Interactive comment on “Prioritization of water management under climate change and urbanization using multi-criteria decision making methods” by J.-S. Yang et al.

J.-S. Yang et al.

Received and published: 30 January 2012

Fig. 1. Map of the study watershed

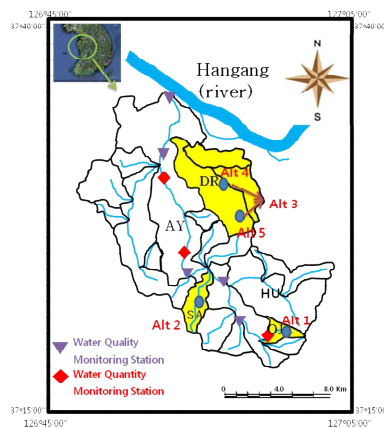
Figures: Figure 2 must be improved as it is hard to see exactly where the study site(s) are located in South Korea and some text is very hard/impossible to read. Hence, the size of the map of South Korea with the location of the study site should be increased including the fonts of the geographical coordinates. Fonts in the maps of the different sub-watersheds and the scale bar should be increased in size especially for the DR watershed. Ans) We redraw fig. 2.

Fig. 3. Summary of forecasted temperature and precipitation results

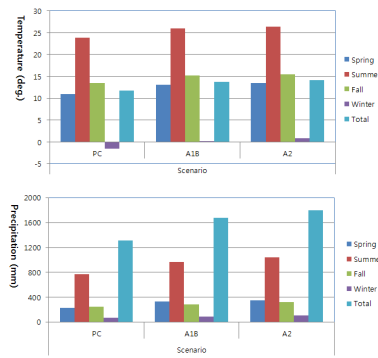
5) Additional information on results of downscaled GCMs should be presented and illustrated in section 4.2. Ans) We added a figure and some sentences as follows: The daily mean temperature and precipitation are calculated for the study watershed using CGCM3 model output from A1B and A2 emission scenarios for the future scenarios (2011-2100) and SDSM. Chung et al. (2011) showed the procedure and results for calibration and verification. From the Mann-Kendall test (2010-2100), it can be estimated that Seoul and Suwon weather stations have a strong tendency for increasing temperatures and precipitation as shown in Fig. 2. The ave. temperature at Seoul and Suwon stations would increase by 1.6°C and 2.0°C under A1B and 2.0°C and 2.4°C under A2 during the period 2010-2100, respectively. Especially, the summer temperature of Seoul (A2) would increase up to 4.2°C. The ave. precipitation at Seoul and Suwon stations are 1896.9 mm and 1679.5 mm under A1B and 2029.5 mm and 1803.6 mm under A2. Especially, the summer intensity of Seoul station increased severely from 845.9 mm to 1317.3 mm (A2) and the remaining seasons didn't show any extreme increases.

A figure in section 4.2 illustrating the downscaled projected changes of SRES scenario A1B and A2 would be helpful Ans) We added a figure to illustrate the downscaled projected changes of SRES scenario A1B and A2. You can see Fig. 2.

P9900, L 11-20: It would be very helpful to show the projected climate change in a figure for easier overview Ans) We added Fig. 2 and a specific description in section

Fig. 2. Summary of forecasted temperature and precipitation results
